Kelli Cahill
Project Planner
Napa County Planning, Building, & Environmental Services Department
1195 Third Street, Suite 210
Napa, CA 94559
kelli.cahill@countyofnapa.org
Tel: (707) 265-2325 Fax: (707) 299-4271

November 21, 2014

These comments are submitted on behalf of the Center for Biological Diversity (“Center”) and the Napa Group Sierra Club (collectively “conservation groups”) on the Draft Environmental Impact Report (“DEIR”) for the proposed Walt Ranch vineyard development project (“Project”). The DEIR fails to adequately analyze a range of environmental impacts, mitigation measures, and alternatives. At a minimum, the DEIR must be revised and recirculated to remedy these deficiencies. The Project must also be revised to resolve its conflicts with the County of Napa General Plan, failure to comply with the California Environmental Quality Act (CEQA) as well as the California Endangered Species Act (CESA).

Figure 1 – Ideal Wildlife Friendly Fence

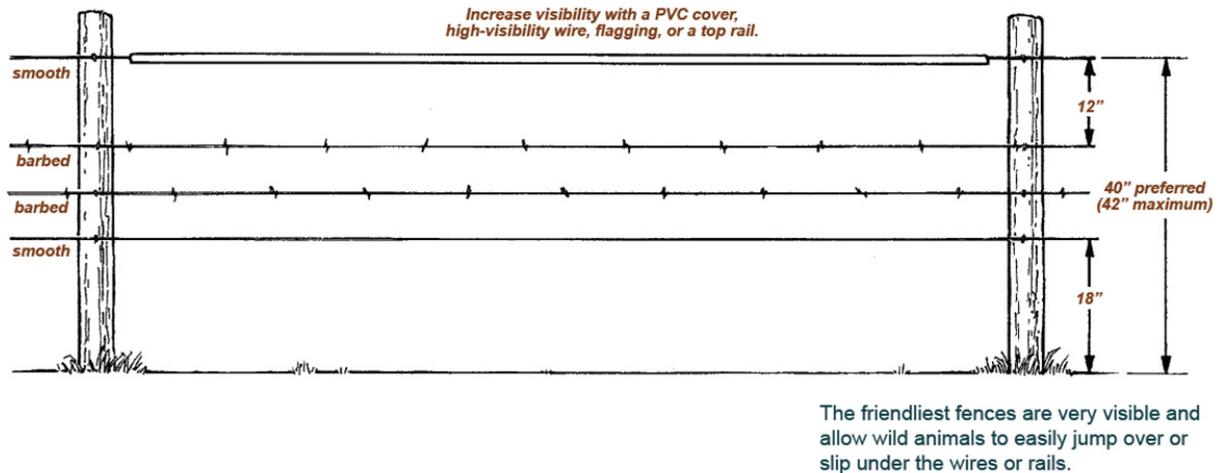
Because death is, by any measure, a significant “reduction of wildlife movement,” the conservation groups request that the County take this threat seriously and in accordance with Napa County’s General Plan Policies. (Napa County General Plan CON-29 (discussing Policy CON-18).) Therefore, the conservation groups asks that the County either entirely prohibit the planned fencing at Walt Ranch, or, at a minimum, require the Applicant to only install ecologically friendly fencing to the extent that prohibiting fencing is infeasible.

Figure 2: Contra Costa goldfields habitat overlaid with a map of Walt Ranch

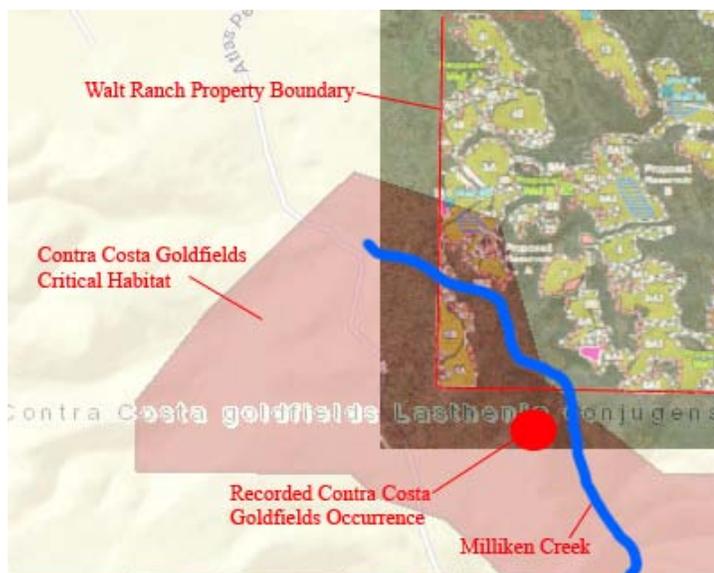
The DEIR recognizes that goldfields habitat was present at Walt Ranch, but fails to mention goldfields critical habitat either within or surrounding Walt Ranch. (See DEIR 4.2-31, 4.2-47.) The DEIR also does not address the recorded goldfields present immediately South of Walt Ranch. (*Id.*; Fig. 2, *supra.*) Milliken Creek runs through Walt Ranch and then continues directly into the goldfields' critical habitat and through the area where goldfields have been located. (See Fig. 2, *supra.*)

To set an acceptable baseline against which to measure the Project's impacts, Napa County needs to discuss the goldfields' critical habitat both on and near Walt Ranch. (CEQA Guidelines § 15125(a).) Because the County has failed to provide an adequate baseline, its nonexistent discussion of impact significance also fails the standards set by CEQA. (*Woodward Park Homeowners Assn, Inc. v. City of Fresno* (2007) 150 Cal.App.4th 683, 687; CEQA Guidelines § 15125(a) & (e).) In the next draft of the EIR, the County should discuss potential impacts to on-site goldfields critical habitat and the potential for negative downstream effects of continued vineyard operations at Walt Ranch. The County should also mandate mitigation for these effects so that they are below a significant level. (CEQA Guidelines §§ 15126, 15126.6.) Specifically, we request that all proposed vineyard plots within or near the goldfields' critical habitat not be developed, and that all potential goldfields habitat on-site be improved and set aside for conservation. Also, the County should prohibit all herbicide use that may wash or drift into Milliken Creek or other parts of the goldfields' critical habitat. The next draft of the EIR should also discuss any additional federal permits the Applicant needs to develop on the goldfield's critical habitat, such as a federal ITP. The County should also discuss whether Section 7 ESA consultation is required for the County to approve the Applicant's erosion control permit.
